LR-N17-0091  
LAR S16-04

Subject: Supplemental Information Needed for Acceptance of Requested  
Licensing Action Re: Containment Fan Cooler Unit (CFCU) Allowed  
Outage Time (AOT) Extension (CAC Nos. MF9364 and MF9365)

Enclosure SA-LAR-010, "Salem CFCU AOT Extension LAR Supplemental Response"

**Salem Generating Station  
CFCU AOT Extension LAR Supplement**

**FIGURE 3-1  
DELTA INTERNAL EVENTS RISK DUE TO TWO CFCUS BEING UNAVAILABLE**

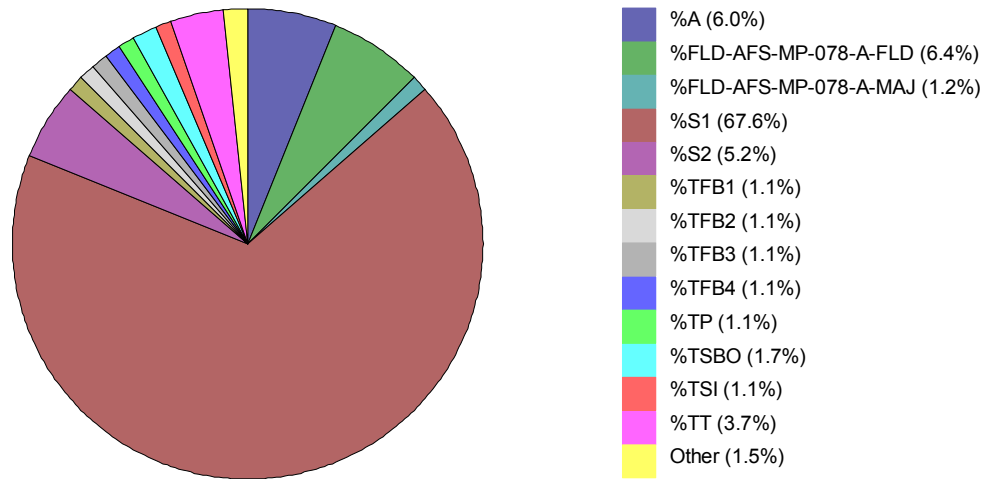
1. For the risk contribution associated with internal fires, the PRA should include
  - a. A quantitative evaluation (i.e., PRA) that:
    - i. Meets an NRC-endorsed industry standard;
    - ii. Is peer reviewed in accordance with RG 1.200; and
    - iii. Includes the result of the reviews, including all open findings and observations (F&Os), and the change in risk.

- b. A sufficient qualitative evaluation of the risk contributors that:
        - i. Is of sufficient scope and depth. If the IPEEE fire evaluation is used as a basis, deficiencies in the evaluation that result from using the EPRI FIVE methodology should be addressed, including using NRC-approved methods for plant partitioning, to account for multiple spurious actuations, for plant response modeling, for fire scenario selection and analysis, to account for human reliability, for fire risk quantification, and to account for uncertainty;
        - ii. Includes a discussion that clearly demonstrates why the risk contributions will not affect the decision as to the acceptability of the increase in risk;
        - iii. If the basis for the qualitative evaluation relies on a PRA, the PRA should meet the criteria outlined above for quantitative evaluations.

2. For the risk contribution associated with seismic events, the LAR should include:
  - a. A quantitative evaluation (i.e., PRA) that:
    - i. Meets an NRC-endorsed industry standard;
    - ii. Is peer-reviewed in accordance with RG 1.200; and
    - iii. Includes the result of the reviews, including all open findings and observations (F&Os), and the change in risk.

- b. A sufficient qualitative evaluation of the risk contributions that:
        - i. Is of sufficient scope and depth. The evaluation should be performed using current state-of-knowledge where applicable, including updated site-specific seismic hazard analyses, seismic fragility assessments, and seismic systems analysis; and
        - ii. Includes a discussion that clearly demonstrates why the risk contributions will not affect the decision as to the acceptability of the increase in risk.
        - iii. If the basis for the qualitative evaluation relies on a PRA, the PRA should meet the criteria outlined above for quantitative evaluations.

A review of the internal events model evaluation for this AOT extension provides guidance for performing a qualitative fire hazards analysis based on a conservative approach that makes use of the SA115A FPIE MOR and an Appendix R type of philosophy. From the initiating event distribution of the internal events delta risk shown in Figure 3-1, note that 67.6%, 5.2% and 6.0% of the CDF increase comes from %S1 (Intermediate LOCA Initiating Event), %S2 (Small LOCA Initiating Event), and %A (Large LOCA Initiating Event), respectively. Figure 3-1 was generated by taking the quantitative PRA results from the SA115A FPIE CFCU AOT extension case and subtracting the similar cutsets found in the base case. Then, the percent contribution for initiators of the remaining cutsets is displayed graphically in Figure 3-1. A review of typical industry results shows a negligible likelihood that a fire leads to %S1, %S2, or %A [12]. Thus, these scenarios can be ignored while estimating fire risk increases associated with the CFCUs out of service. Consequential small LOCAs, such as RCP seal failures and inadvertent power operated relief valve (PORV) openings, do not fall into %S2. They are initiated by various flooding and other transient scenarios and are covered within the analysis given below.

The next important initiating events are the 2 flooding initiating events, %FLD-AFS-MP-078-FLD and %FLD-AFS-MP-078-MAJ, which contribute about 7.6% of the risk increase (the risk increase varies slightly depending on which CFCUs are considered to be failed). The risk scenarios of interest are a flood from the Auxiliary Feedwater system in a lower level of the Auxiliary Building (AB) leading to PRA transient event tree sequence TTS24. The TTS24 internal event sequence is characterized by a trip with or without the power conversion system (PCS) available, secondary side heat removal failures that generally involve failure to implement available secondary cooling systems, and successful operation of feed and bleed heat removal using Safety Injection and PORVs. However, feed and bleed operation fails late due to the inability to recirculate water from the containment sump. The initiating events fail Service Water to an otherwise operable fan cooler and fail the MOVs necessary to operate the CSS, causing a high temperature in containment leading to possible sump recirculation failures.

Using the FPIE PRA results as a reference, specific sequences of importance relevant to the unavailability of CFCUs can be identified. The important characteristic of these sequences is failure of the steam generator cooling and containment cooling functions. The flooding sequences are the only scenarios in the FPIE that directly cause the failure of these two functions, but they contribute less than 10% of the risk increase. Since the 4<sup>th</sup> AFW pump and support systems are outside the Auxiliary Building and the CSS and its support systems are located inside the Auxiliary Building, no fire can cause the failure of both functions. Knowledge of this arrangement, along with the Salem design criteria can be used to assess the fire risk. These particular scenarios would be applicable to the potential fire events of concern.
